## ABBREVIATED PLAT AGENDA

April 10, 2024

A. **GILCA'S GLADE:** The request is to create four lots from Tract A, Woodland Glade, Plat No. 2016-145, to be known as **GILCA'S GLADE**, containing 6.21 acres +/- . Parcel is located west of S. Highlander Drive, east of W. Conner Court, southwest of W. Bromley Drive and directly north of W. Dora Circle (Tax ID# 7586000T00A): lying within Section 35, Township 17 North, Range 02 West, Seward Meridian, Alaska. In the Knik-Fairview Community Council and Assembly District #3. *(Petitioner/Owner: GE Properties LLC, Staff: Amy Otto-Buchanan, Case #2024-036)*

B. **LAVANWAY HVN:** The request is to create three lots from Lots 1 & 2, Lavanway Subdivision, Plat No. 2016-182, to be known as **LAVANWAY HAVEN**, containing 7.22 acres +/- . The property is located south of Threemile Lake, west of W. Hazel Avenue, and directly north of Bocker Lake (Tax ID #7602000L001 / L002); within the SW ¼ Section 11, Township 16 North, Range 03 West, Seward Meridian, Alaska. In the Knik-Fairview Community Council and in Assembly District #5. *(Petitioner/Owner: Linda Lavanway, Staff: Matthew Goddard, Case #2024-037)*

HOUSTON, ALASKA  
**GILCA'S GLADE**  
 SITE PLAN - DESIGN  
 GRADING-DRAINAGE PLAN

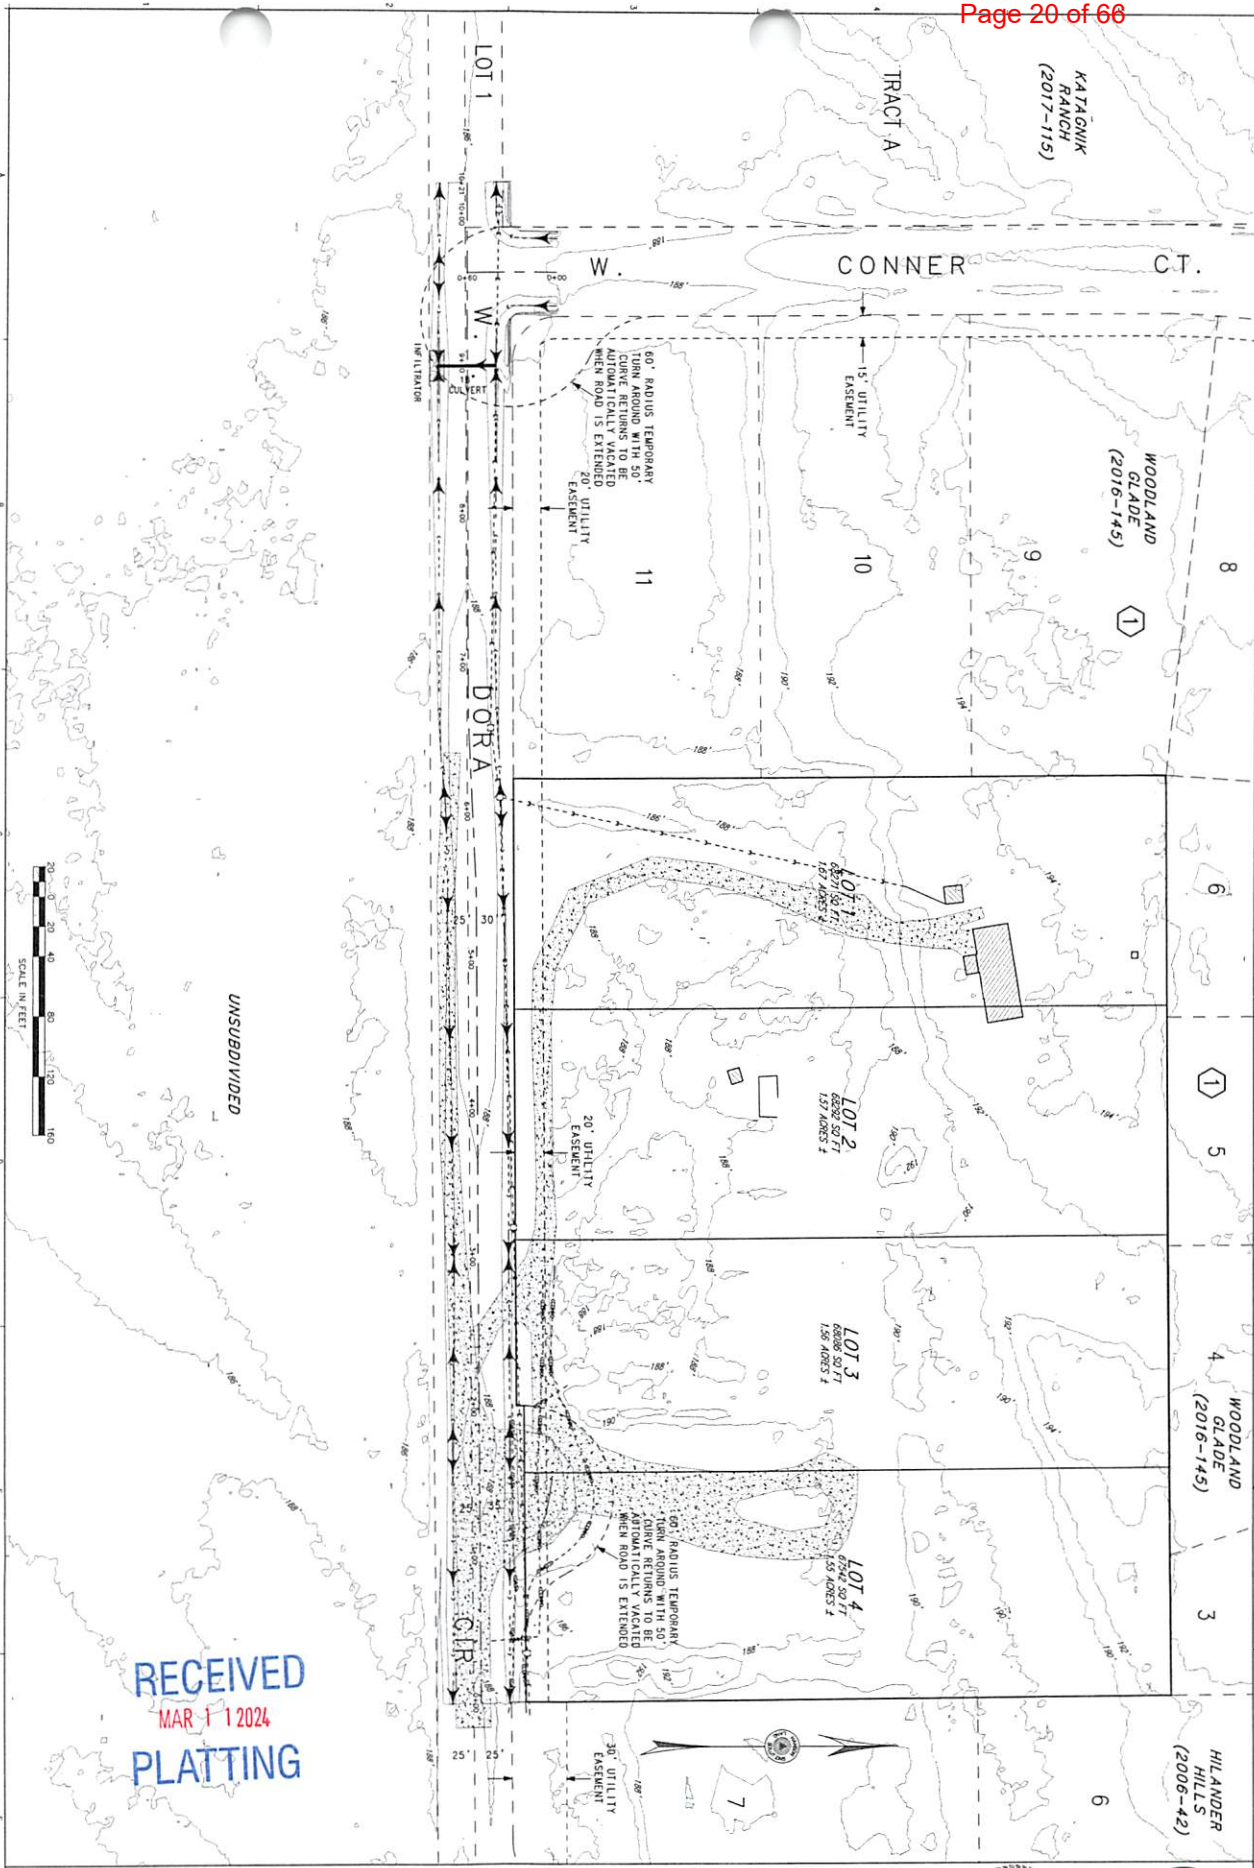
**Comments:** Department of Public Works PD&E (**Exhibit F**) notes an average daily traffic estimate was not required and therefore, not reviewed. The soils report indicates soils were classified using sieve analysis; however, the test results were not supplied. Engineer to provide results or amend the soils report. *Staff notes engineer of record has certified the requirements of MSB 43.20.281(A) have been met.* Construct W. Dora Court through to W. Conner Circle and coordinate the removal of the temporary cul-de-sacs with DPW so they are removed at the end of the warranty period (see **Recommendation #4**). Development Services (**Exhibit G**) notes there are three unpermitted driveways on the parcel. All driveways were constructed prior to 2017, so fees will be waived if application is made before September 2024. Petitioner to apply for driveway permits for all existing driveways and provide copies of the application to Platting staff (see **Recommendation #5**).

3. Pay postage and advertising fees.
4. Construct W. Dora Circle from the temporary cul-de-sac west to the intersection of W. Conner Court, to residential street standards according to the 2022 Subdivision Construction Manual (SCM):

- a) Submit drainage report and other construction plans to Department of Public Works (DPW) per SCM F01.2;
  - b) Arrange preconstruction conference with DPW per SCM F01.3, sign Subdivision Construction Plan, pay inspection fee, and obtain Notice to Proceed from Platting staff;

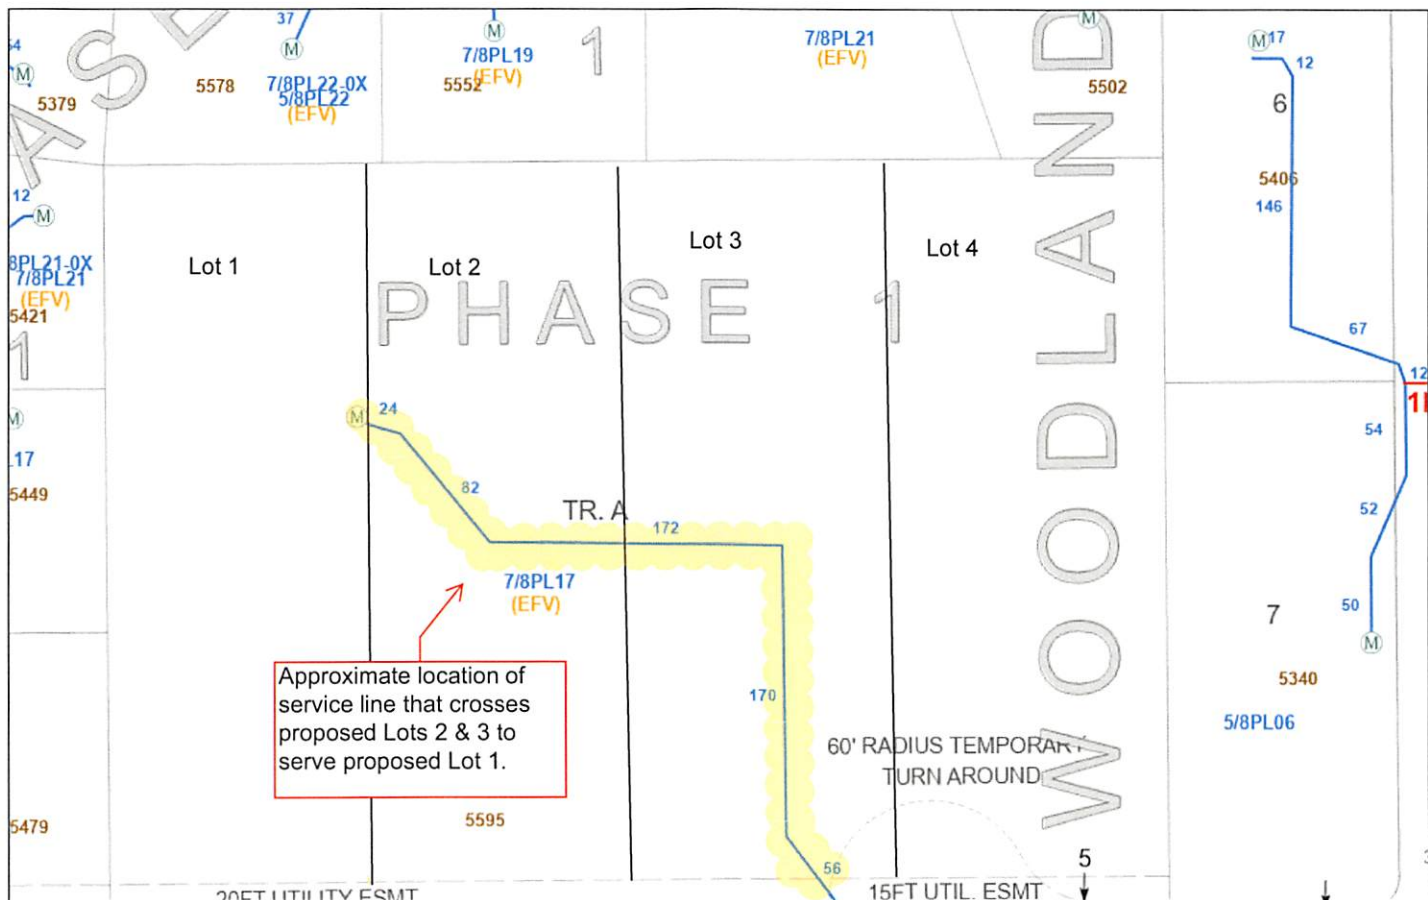
ENSTAR Natural Gas Company, LLC has reviewed preliminary plat GILCA's GLADE (MSB Case # 2024-036) and advises that there is an existing natural gas service line that crosses proposed Lots 3 and 2 to serve proposed Lot 1. Attached is an approximate as-built for your reference. ENSTAR objects to this plat unless one of the following scenarios is met:

1. Add a ten foot (10 FT) wide natural gas easement, centered on the existing natural gas service line on proposed Lots 3 and 2.
2. Owner signs an ENSTAR Natural Gas Easement document for a ten foot (10 FT) wide natural gas easement, centered on the service line at this location.
